Our ref: 044985

**Response to Geotechnical Peer Review and Updated Assessment – Cell 20-1 Slope Issue
Clean Harbors Lambton Landfill Site**

The purpose of this letter is to provide responses to the comments contained in the Thurber Engineering Ltd. letter dated February 2, 2022 and titled “Geotechnical Peer Review, GHD Response Letter of January 28, 2022, Cell 20-1 Slope Stability Issues, Clean Harbors Lambton Landfill Facility, Corunna, Ontario.

Figure 1
North Slope with CKD Buttress

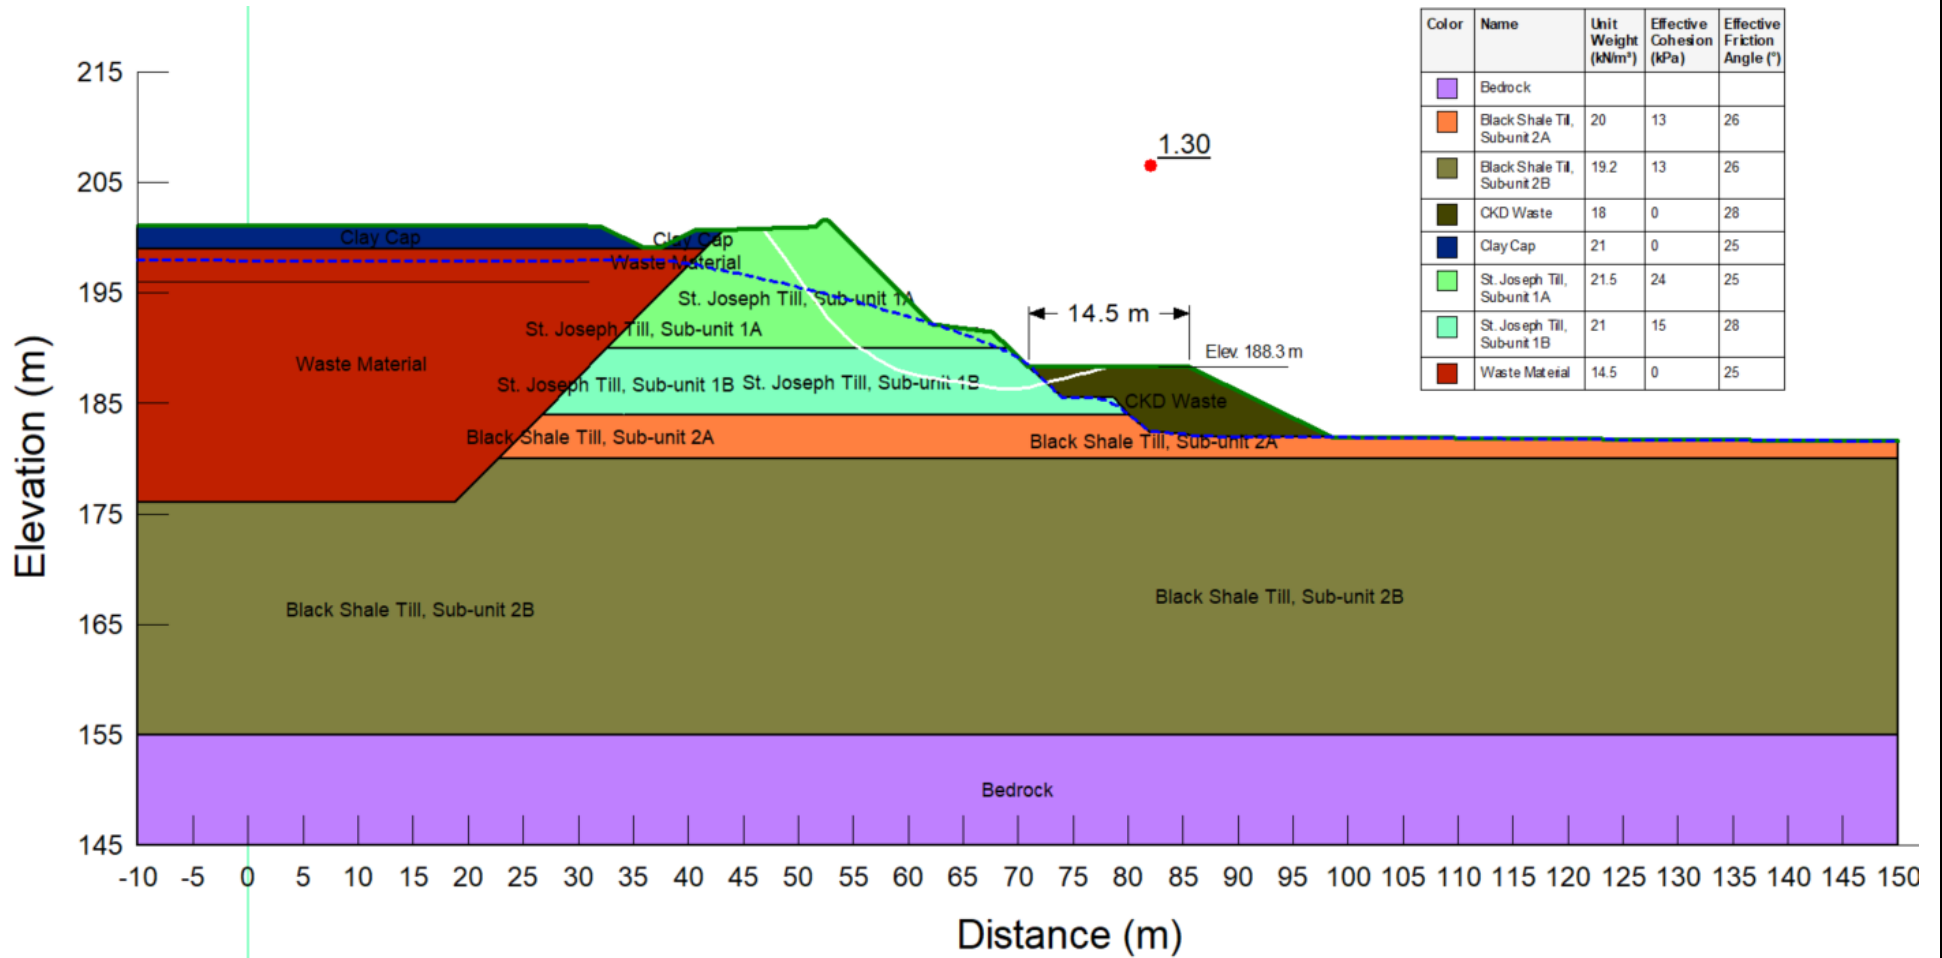
- The North and South slopes require additional buttressing with either CKD material or clay to achieve an FS of 1.3. The dimensions and elevations of the required buttressing are shown on Figures 1 and 3.
- The East slope requires raising the water level (flooding) in the base of Cell 20-1 to improve the FS to 1.3. The target water level is 185.3 m asl.

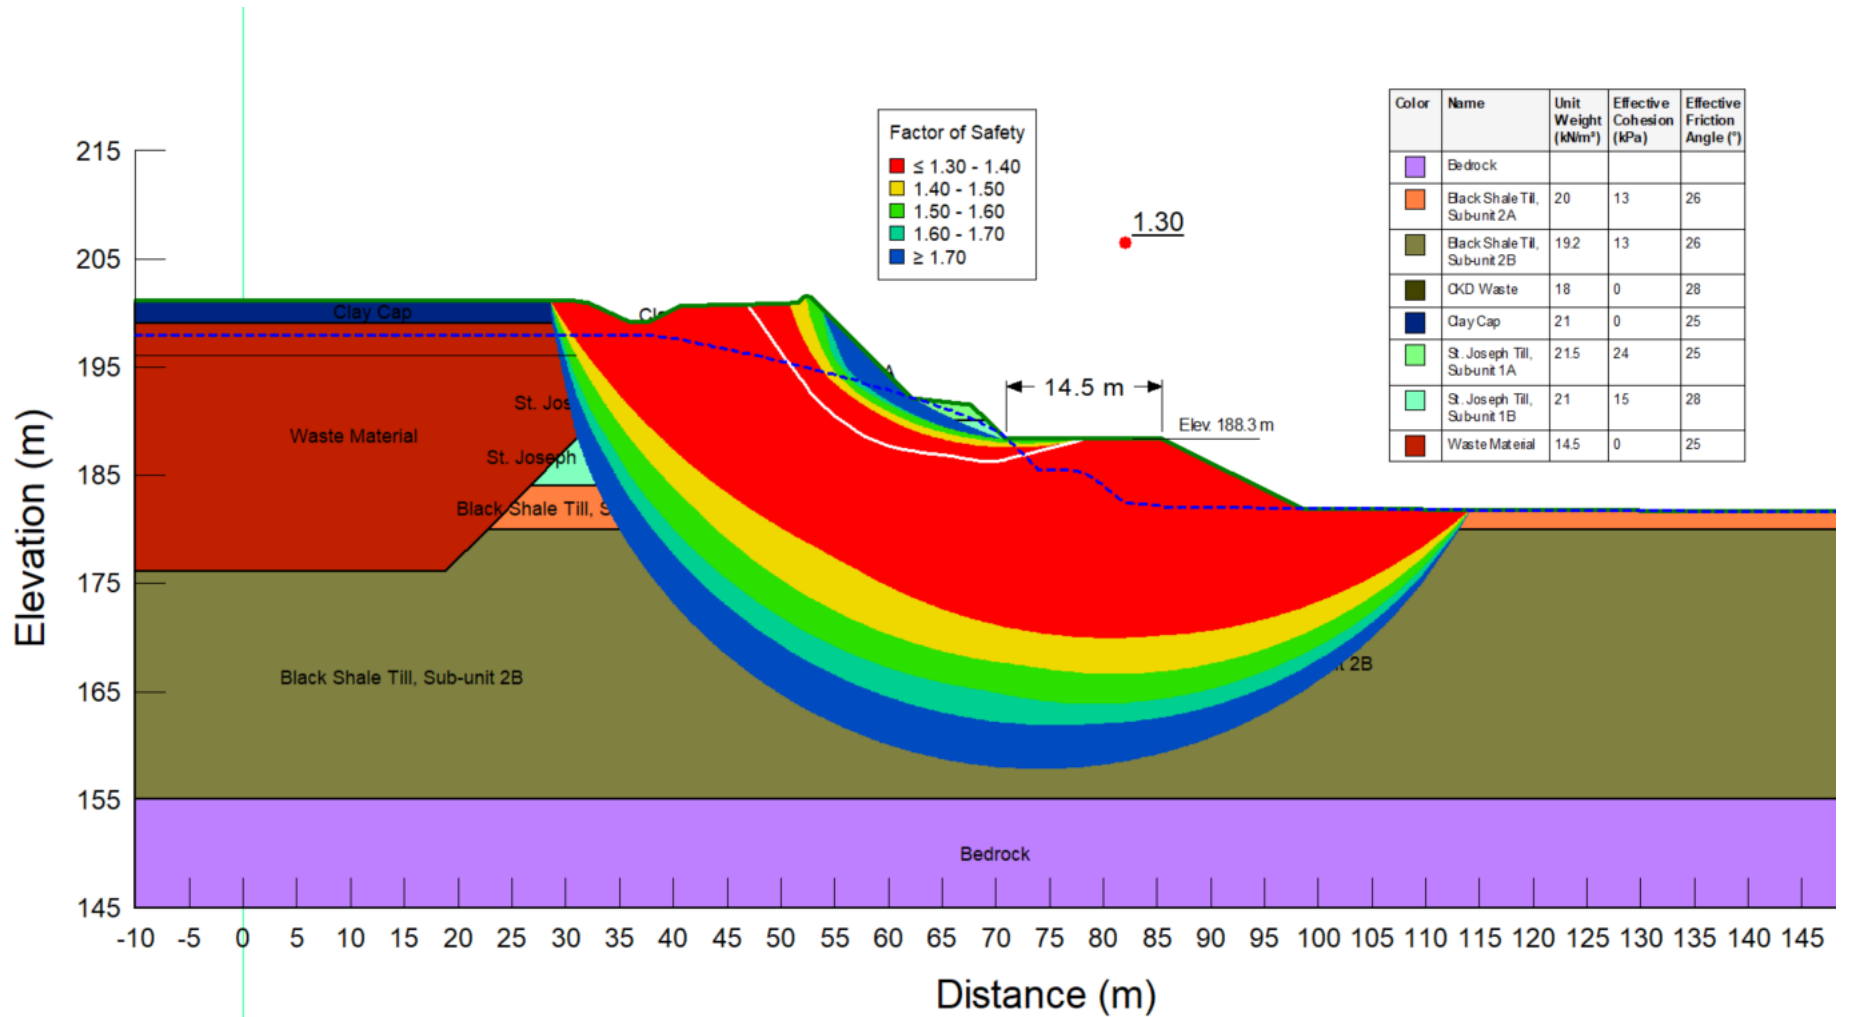
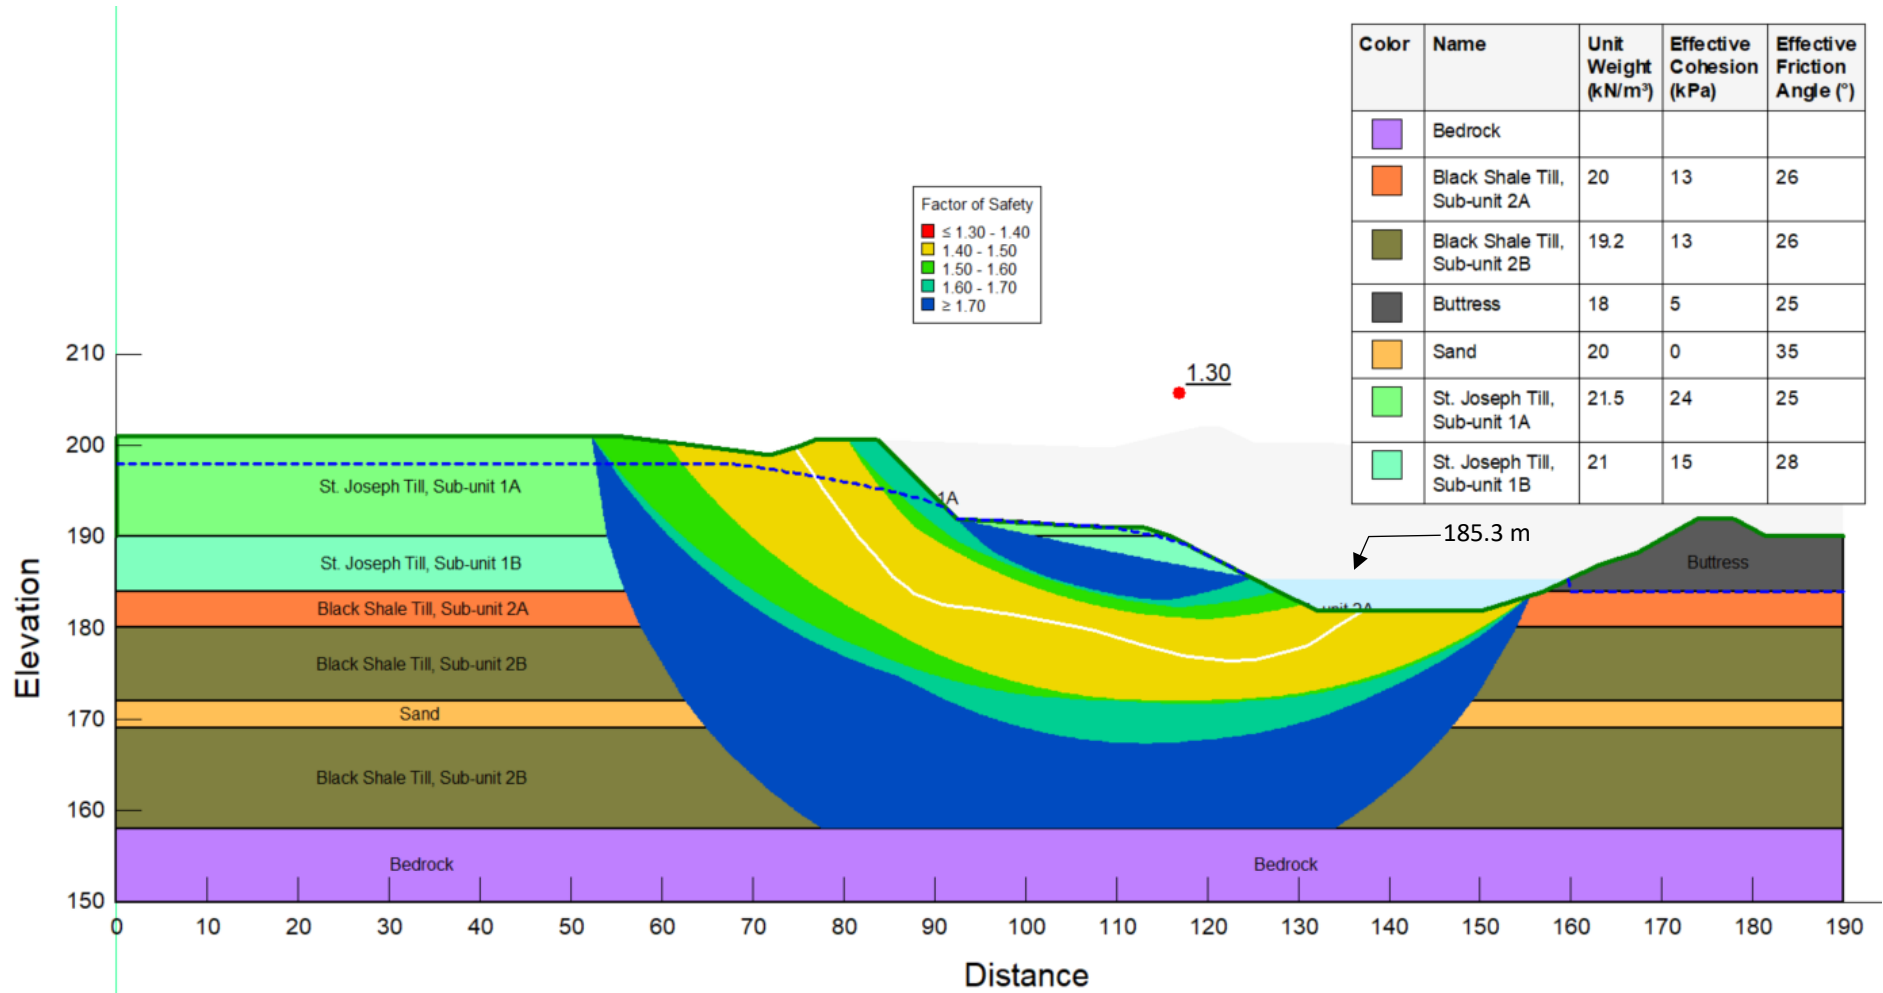
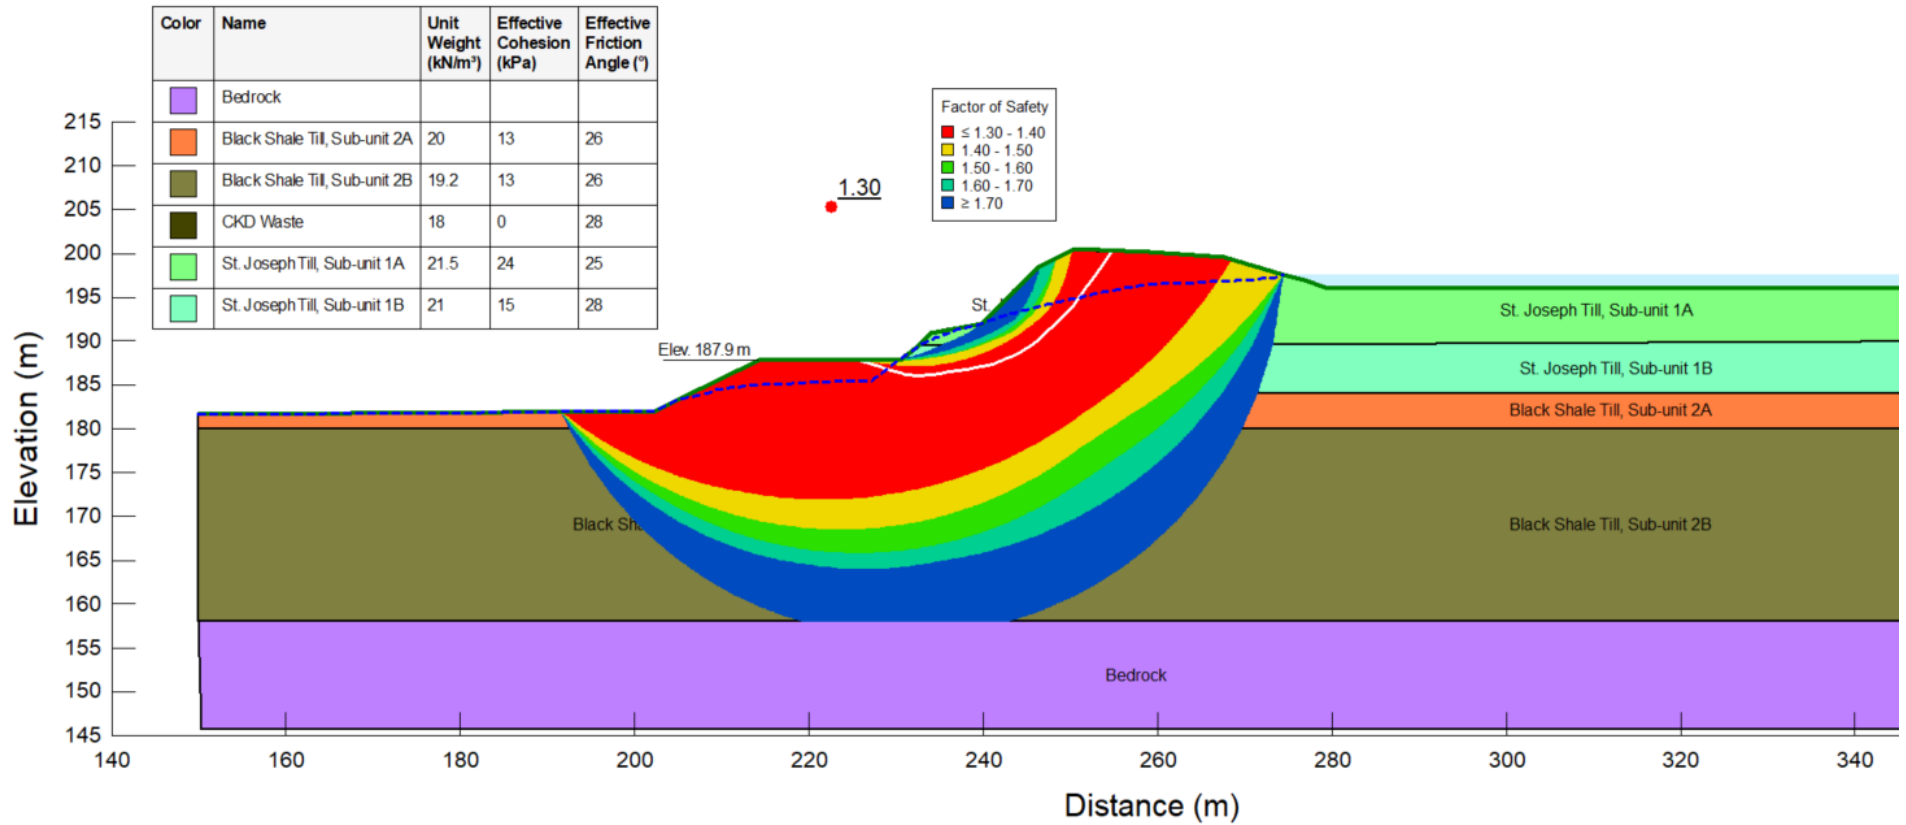
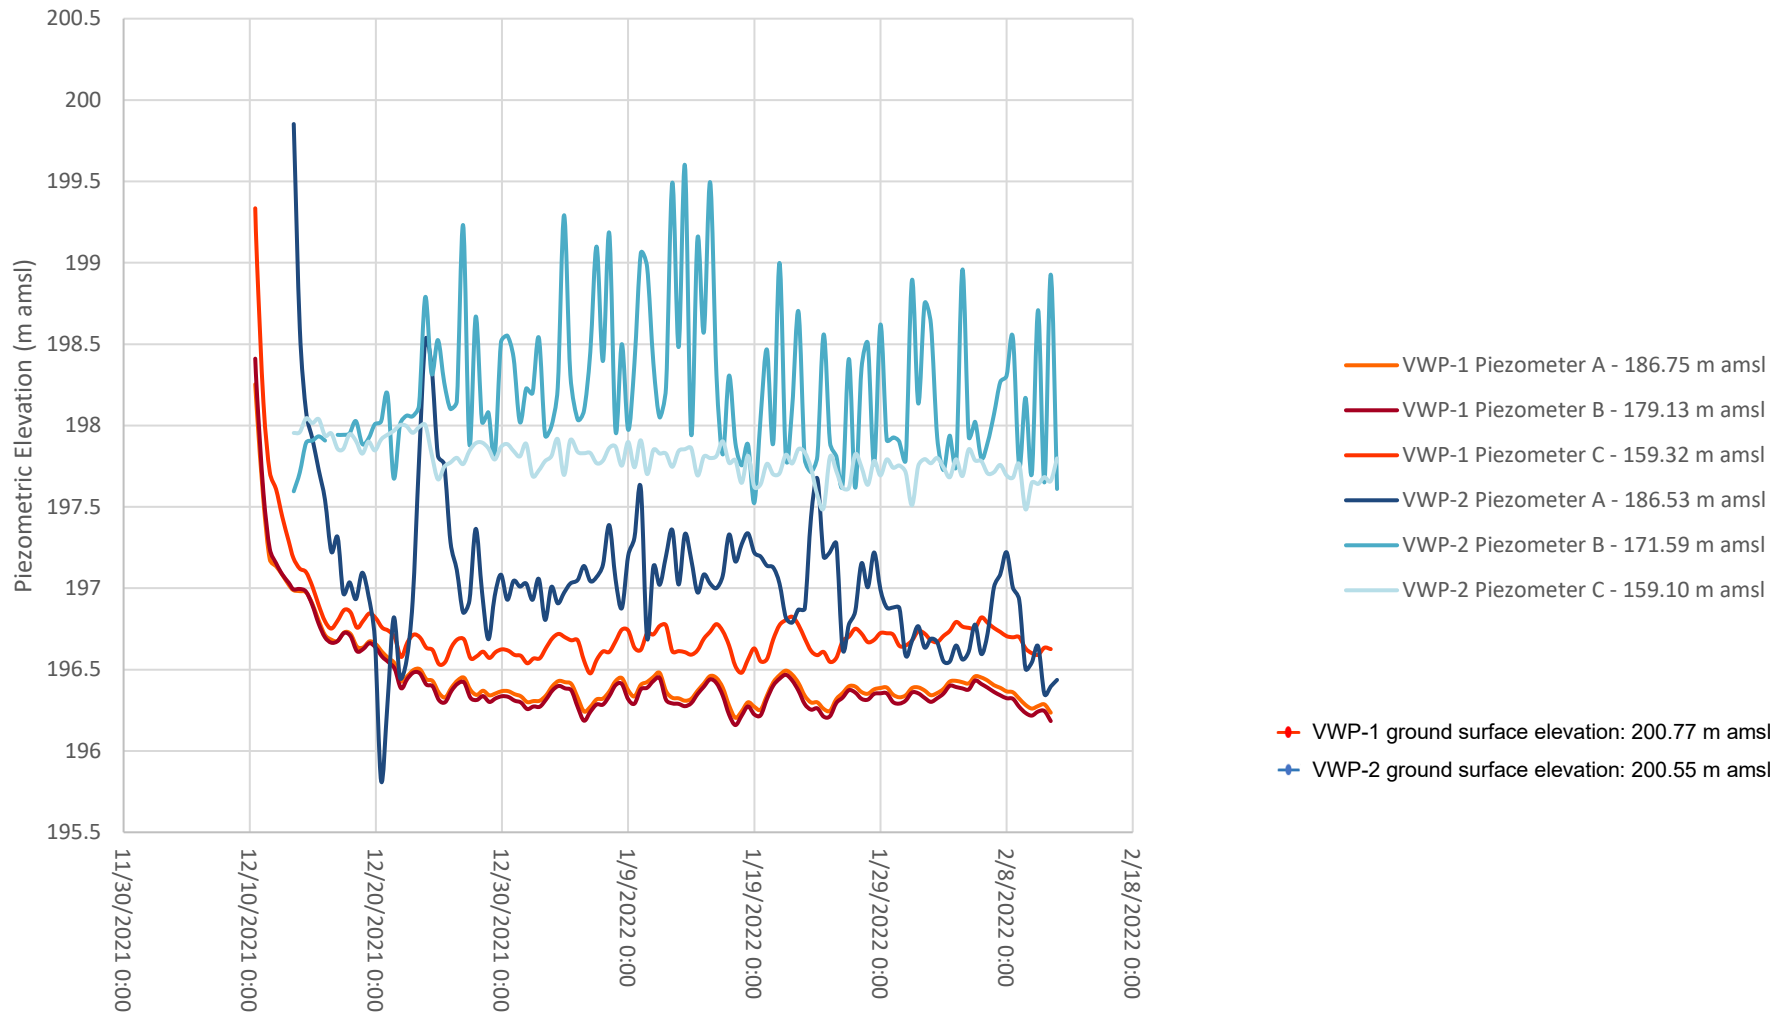
Section 1 3 rd Bullet	Please provide a figure showing the full array of nodes used for modelling each section and the minimum FS calculated for each.	Figures 4, 5, and 6 provides the FS banding for north, east, and south slope models.
Section 1 4 th Bullet	In Figure 7, GHD indicates that CKD has a unit weight of 21 kN/m ³ . Based on our past experience with CKD, this is a very high unit weight. We recommend that this value be confirmed through testing.	A representative sample of CKD was collected by GHD and analyzed. The bulk density of the CKD sample was 1820 kg/m ³ and a unit weight of 18 kN/m ³ has been used in the new models.
Section 2 General	<p>In its initial Geotechnical Design Report, GHD identified a minimum Factor of Safety (FS) for slope design should be 1.3. This minimum FS was continued to be utilized by GHD in its two post slope movement reports, GHD Report and GHD Addendum.</p> <p>In its recent response letter, GHD identifies slope FS that are below 1.3 and as low as 1.16. Given the Site history of slope movements, these low FS represent a significant risk that should be mitigated through design and/or monitoring.</p>	The new models show the required buttress stabilization and water flooding to meet the minimum FS of 1.3. These measures will be implemented by Clean Harbors as soon as site conditions allow this work to be completed safely.

Figures 4, 5, and 6 show additional colour banding for the FS calculated by the model. The colour banding shows ranges for the FS for numerous potential slip surfaces. As can be seen on these figures, the FS increases above the minimum target of 1.3 for deeper slip surfaces.
